Flight Procedures Cover Page	Task Action: P-NOTAM	Task Type: IAP	Estimated Chart Date: 09/03/2026	APWS Task ID: D8F2F55A8CE24E7BA42DD9E161E198DF	APWS Project ID: 4C7FA06132754003BACADF9EDF496BC1
Procedure: RNAV (GPS) RWY 5 ORIG-B		Enroute: NO	Specialist: Johnson, Timothy		Agreement Number:
Airport ID: PAWB			Airport City: BEAVER		State: AK
Facility ID:	Facility Type:	Flight Inspection Remark Type:

RNAV (GPS) RWY 5

BEAVER (WBQ)(PAWB)

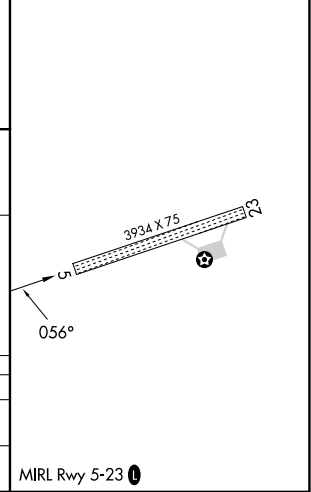
Visibility Initiative (Garmin) - Update IAP visibility minimums IAW Order 8260.3, Chapter 3, Section 3-3. Visibility Minimums.

CATEGORY	A	B	C	D
LNVA MDA	940-1	575 (600-1)	940-1 3/8 575 (600-1 3/8)	NA
CIRCLING	940-1	575 (600-1)	940-1 1/2 575 (600-1 1/2)	NA
